SAN FRANCISCO PLANNING DEPARTMENT

MEMO

RE: Review and Comment for 1355 Market Street (aka 1301-1363 Market Street) – Market Square Project
Case No. 2012.0502E

PROJECT OVERVIEW

Proposed storefront and transom

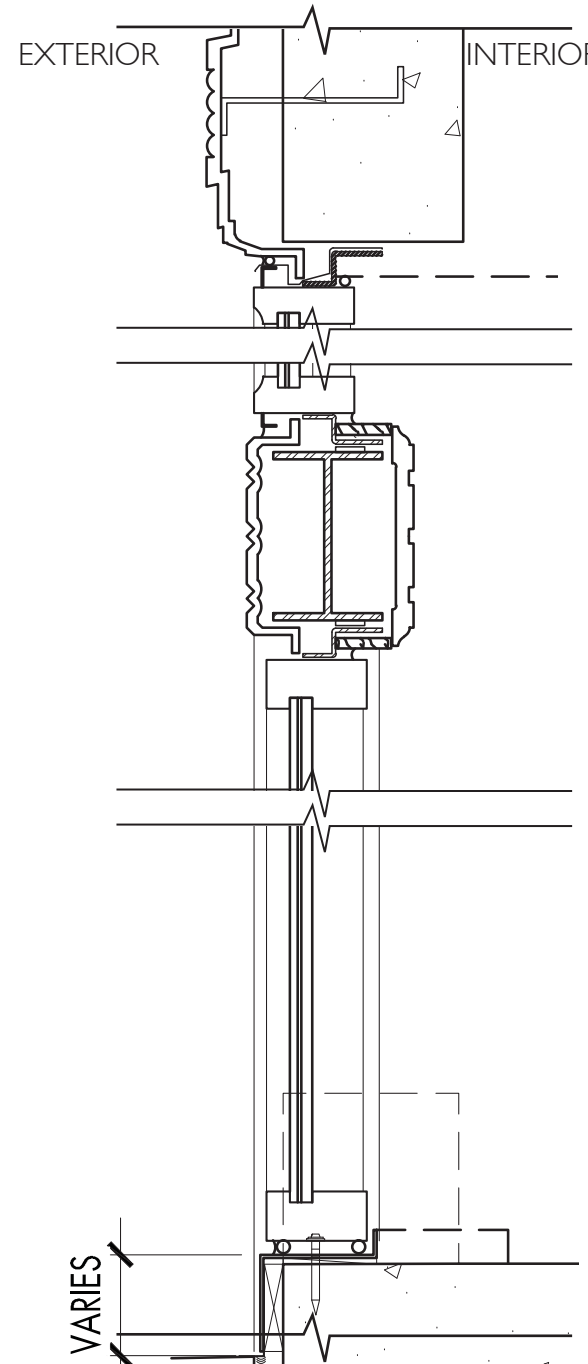
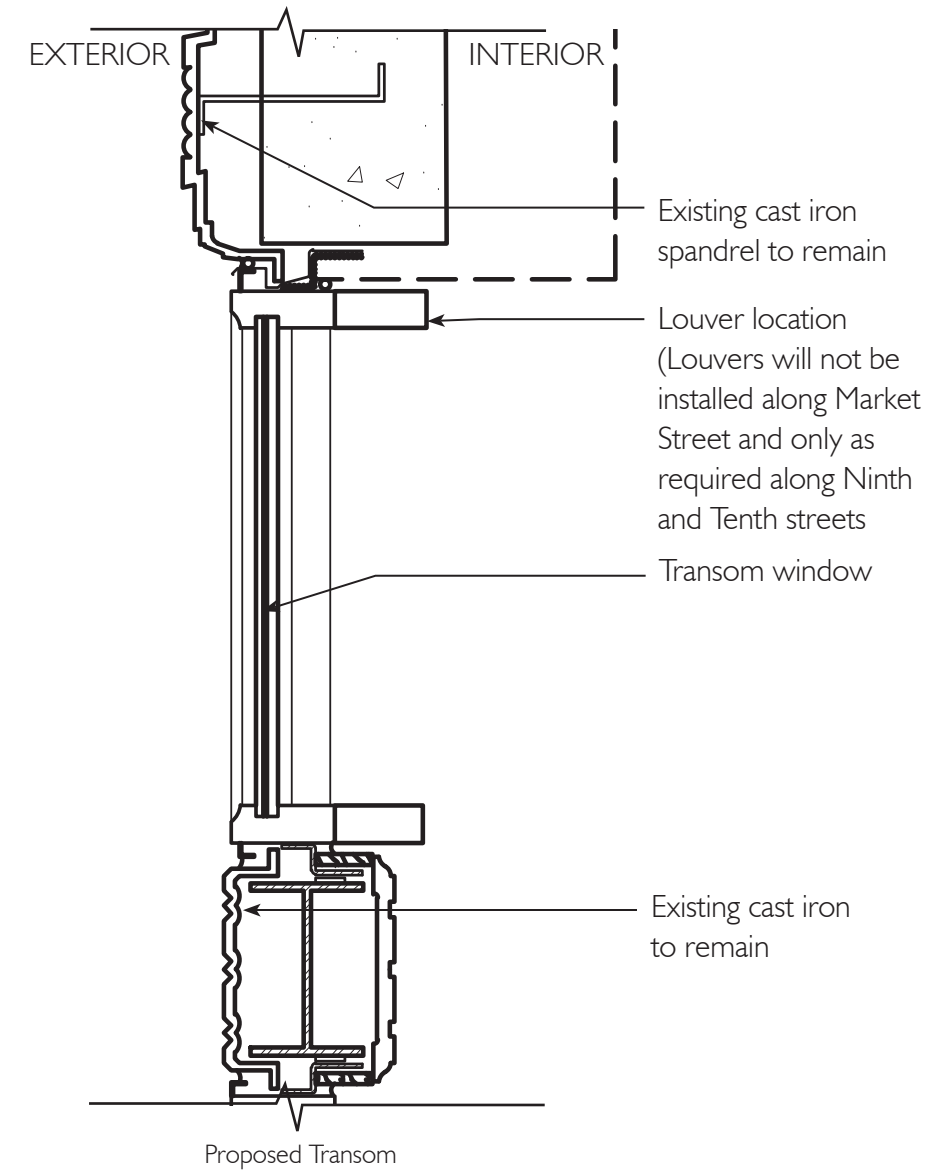
1. Although it has been altered in some locations, the granite base is historic fabric that contributes to the overall character and architectural expression of the base of the building. Removal of this feature and material, and replacement with metal panels, a material that is incompatible with the building base, is not consistent with the Department's Storefront Standards, or with the application of such Standards on numerous storefront projects for Article 11 buildings throughout Downtown. In order to address concerns of the Sponsor regarding visibility and transparency of the storefronts, the Department recommends retaining the granite base but allowing for this feature to be cut down a maximum of 6 inches where it projects above interior floor level due to changes in grade.

2. The size of the new header for the storefront system inappropriately competes with the existing cast iron horizontal member that divides the storefront and transom windows and shrinks the size of the window opening inappropriately. The Department recommends reducing the size of this feature to the extent structurally feasible. While the configuration of the new storefront system (storefront and transoms with centered entry) is typical for buildings of this period, this is not necessarily characteristic of the subject building which historically had much larger storefronts with fewer horizontal and vertical mullions. In this particular case, a more contemporary new storefront system may be appropriate.

3. In concept, the Department believes that the proposed replacement of the transoms and adaption for mechanical louvers as needed at the 9th and 10th Street façades is in conformance with the Storefront Standards and Secretary of the Interior's Standards. Additional details demonstrating the manner in which new transoms will be adapted to accept a louver shall be provided in plans for the Major Permit to Alter. Per the Storefront Standards, the Department also recommends that where louvers are necessary that a decorative grille be installed at the street.

TENTH FLOOR RIBBON WINDOWS, EXISTING AND PROPOSED DETAILS

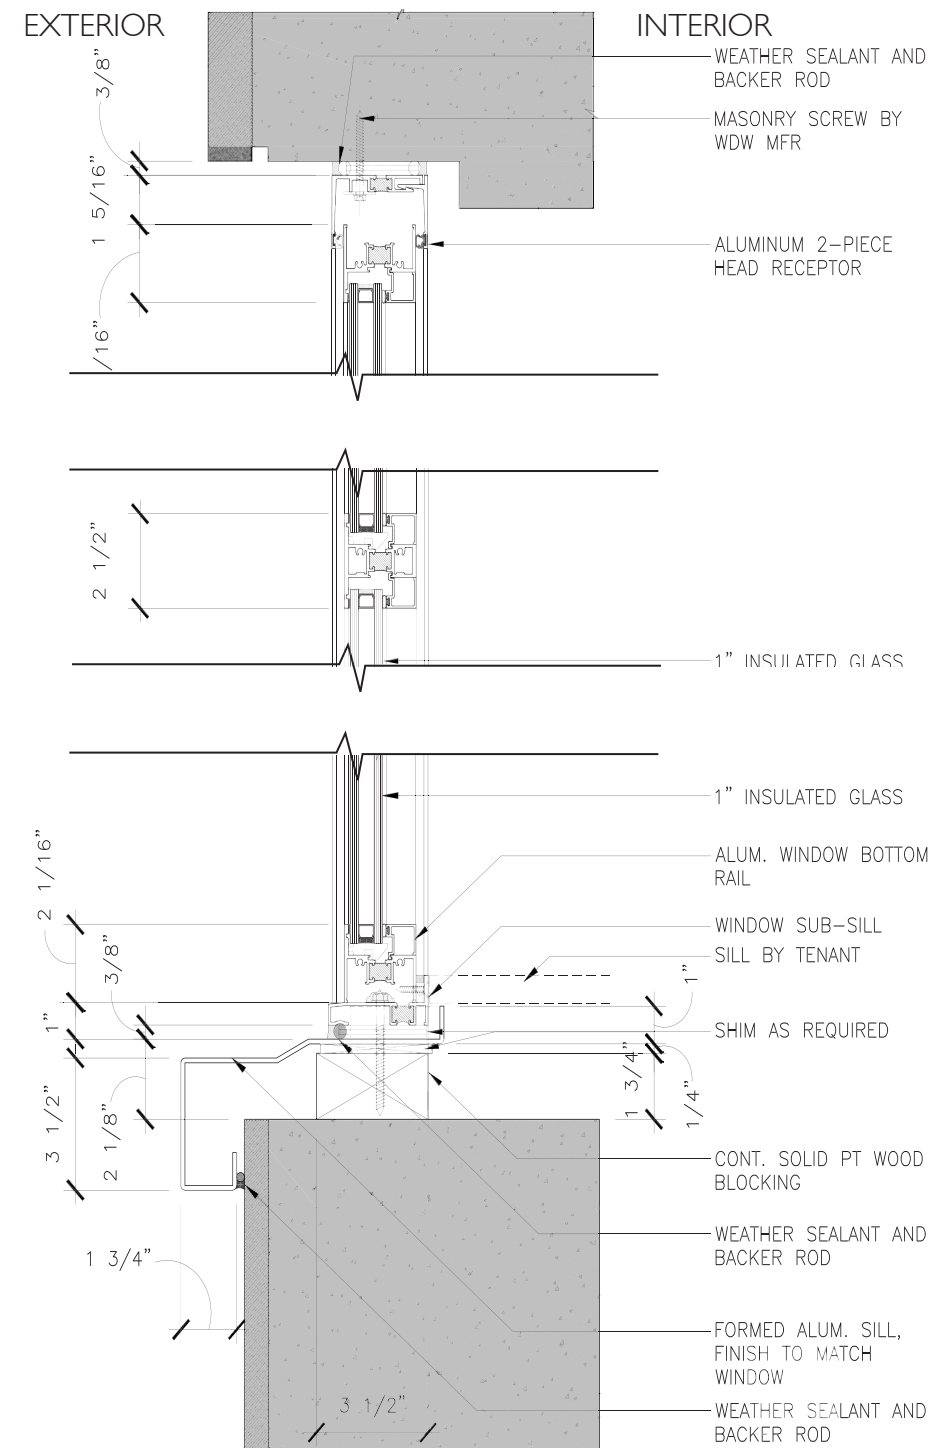
1. The Department believes that lowering the sill at the 10th floor windows, including removal of terra cotta cladding, is not in conformance with the Secretary of the Interior's Standards as it removes historic fabric, removes terra cotta cladding, which is a character-defining feature of the building, and alters the proportion of the parapet along the 9th Street elevation.
2. If the ARC feels that this portion of the proposal is appropriate, then the Department recommends provision of a finish detail that would match existing shall be provided in plans for the Major Permit to Alter.

Existing Stevenson Street facade

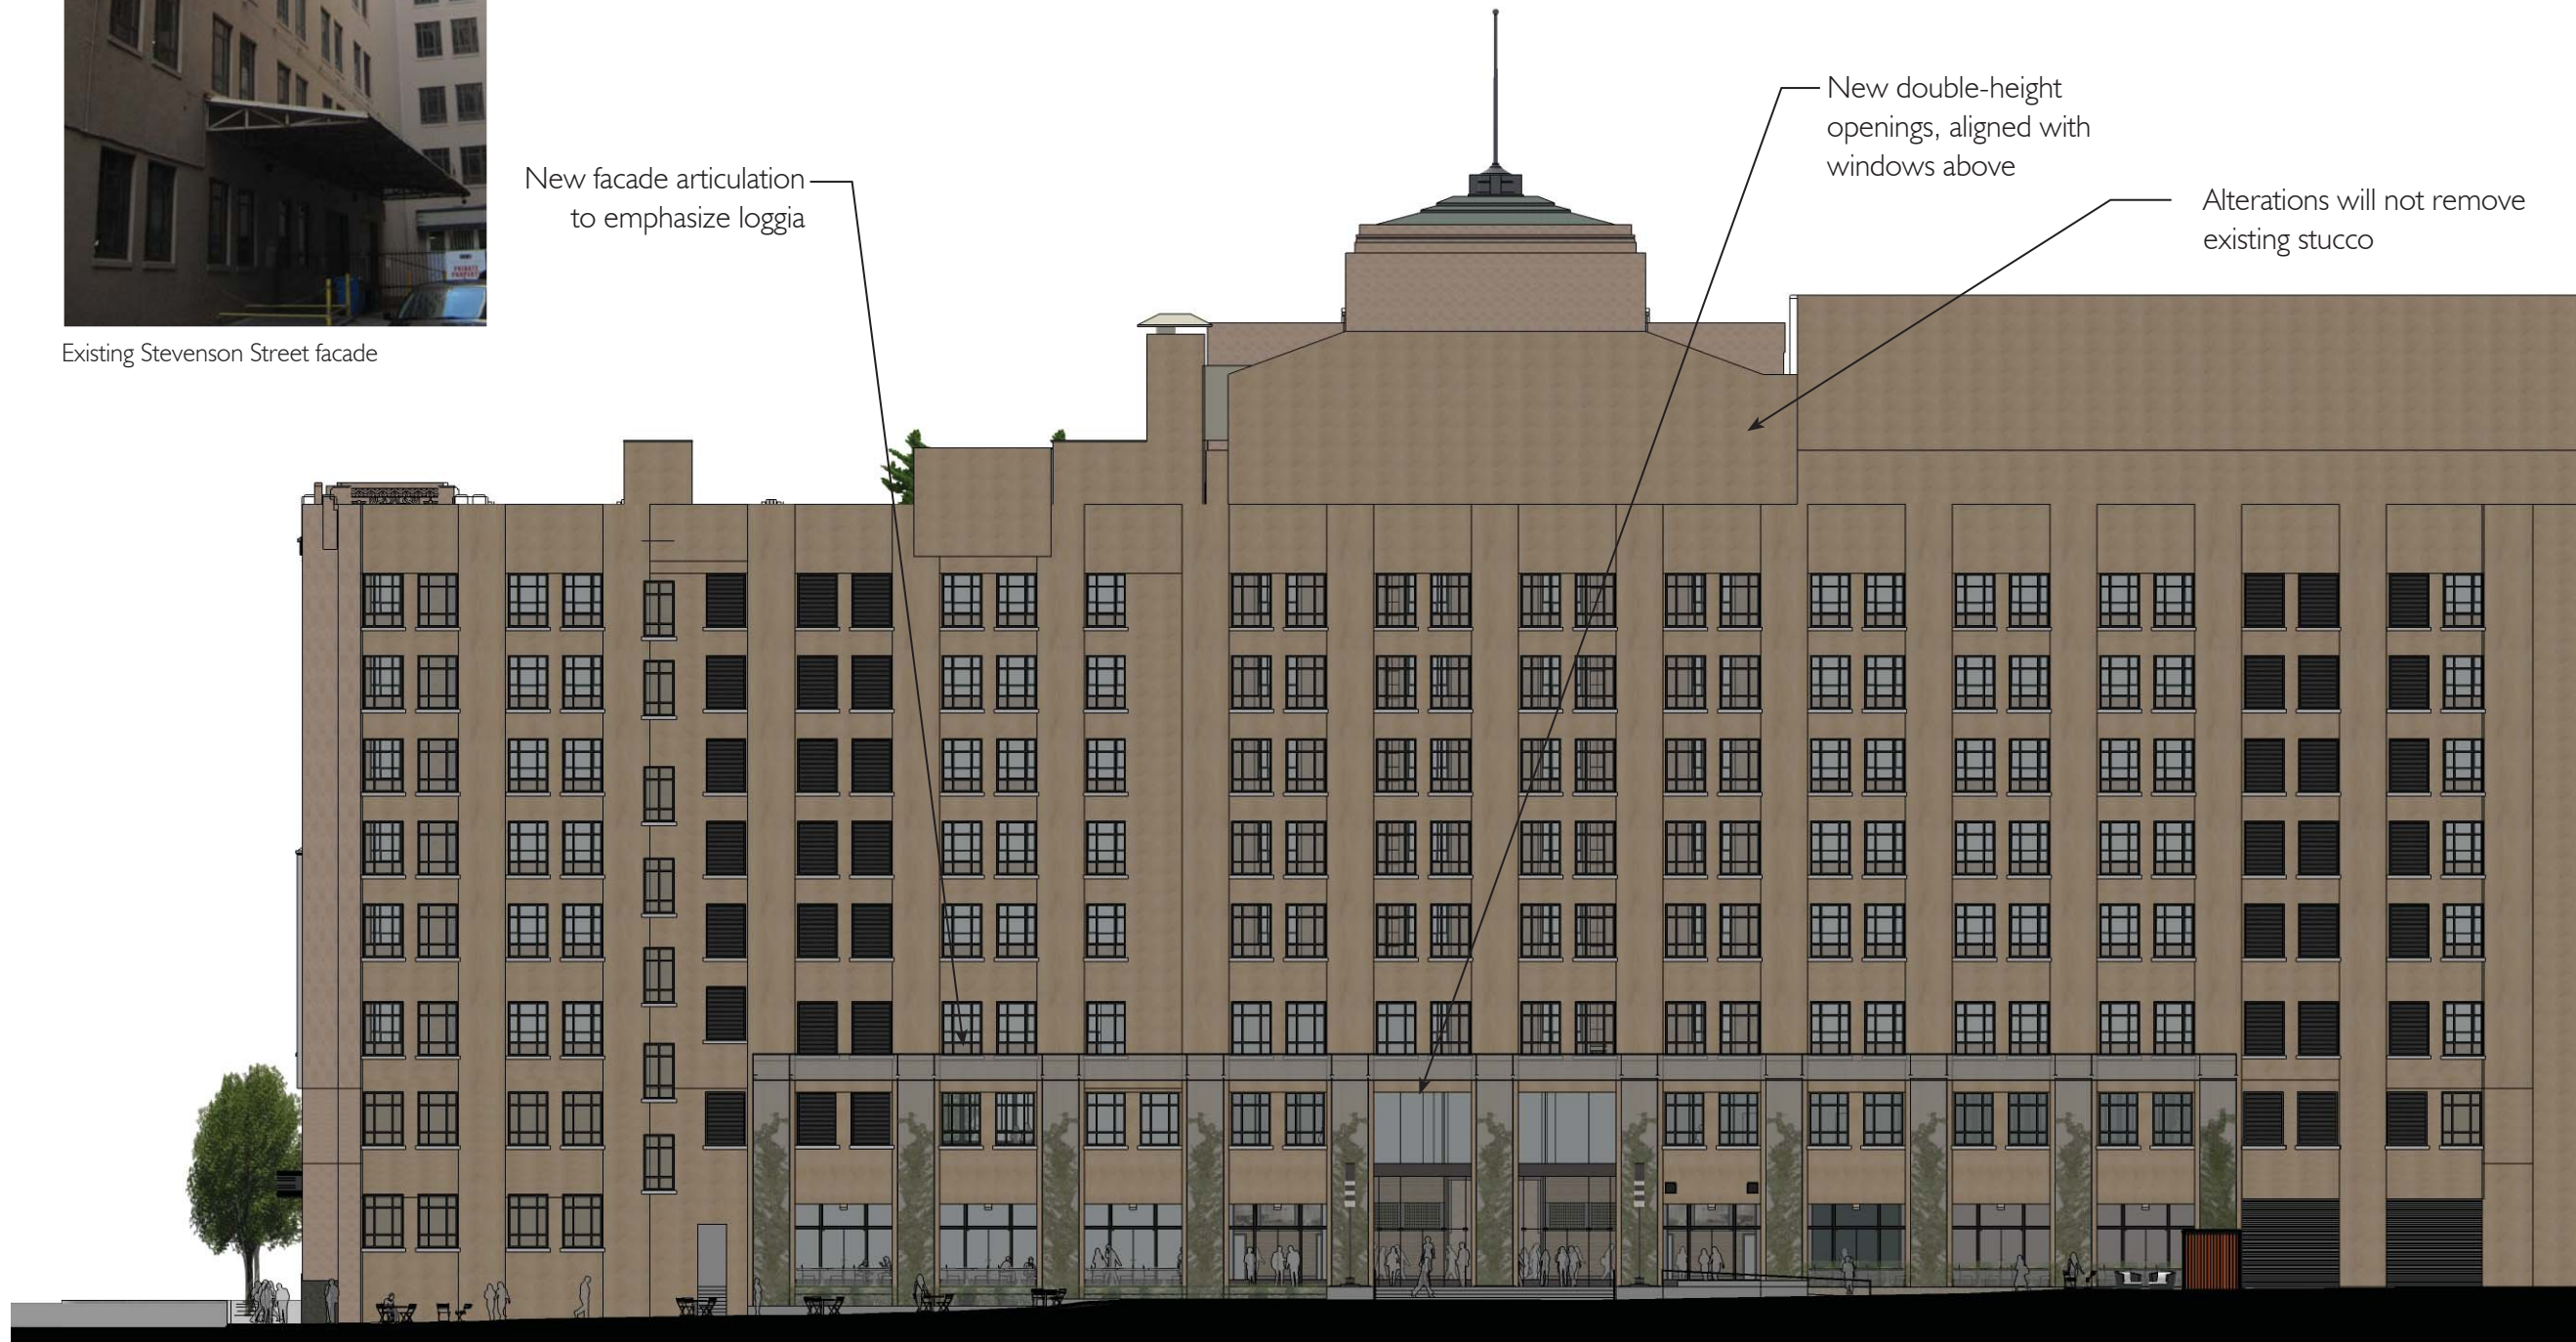
1. The Department believes that the proposed alterations at the Stevenson Street elevation are appropriate and in conformance with the Storefront Standards and Secretary of the Interior's Standards. Proposed alterations will occur on a secondary elevation that is utilitarian in nature, will not remove significant historic fabric, and have been located such that they will be unobtrusive to the primary façades of the building.

Proposed detail of window washing equipment installed through the wall at the tower

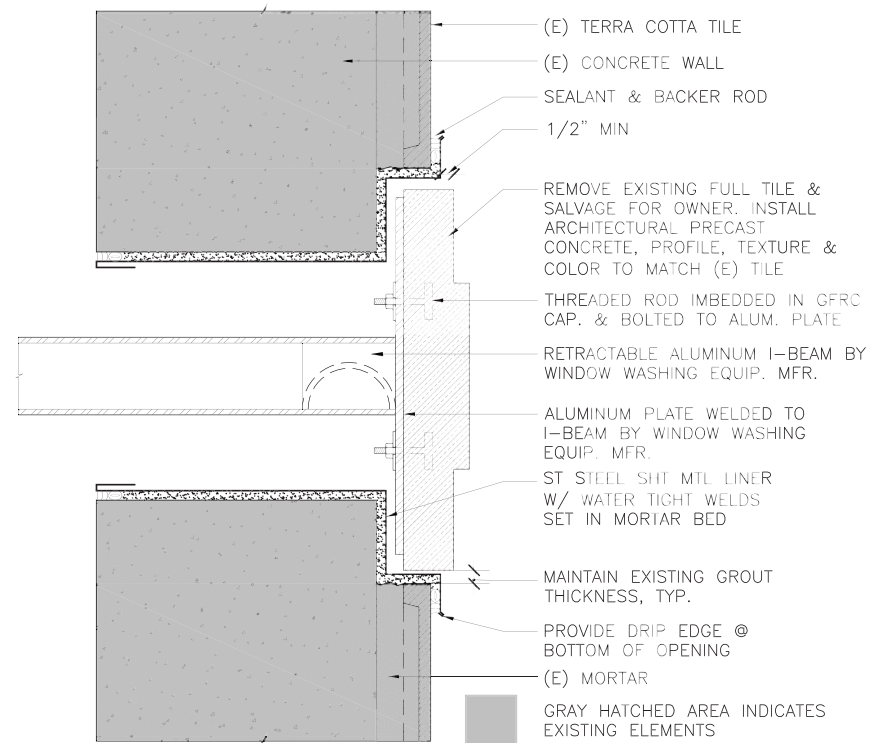
1. The Department recommends avoiding removal and replacement of decoratively detailed terra cotta tiles. At the tower, the Department recommends relocation of the attachment mechanism to avoid removal of the decorative terra cotta and instead remove and replace some of the flat, undecorated terra cotta tiles.
2. The Department recommends avoiding removal and replacement of decoratively detailed terra cotta tiles at the parapet and at the center point of the pilasters on all façades. Details of the attachment mechanisms at the façade shall also be provided in plans for the Major Permit to Alter.
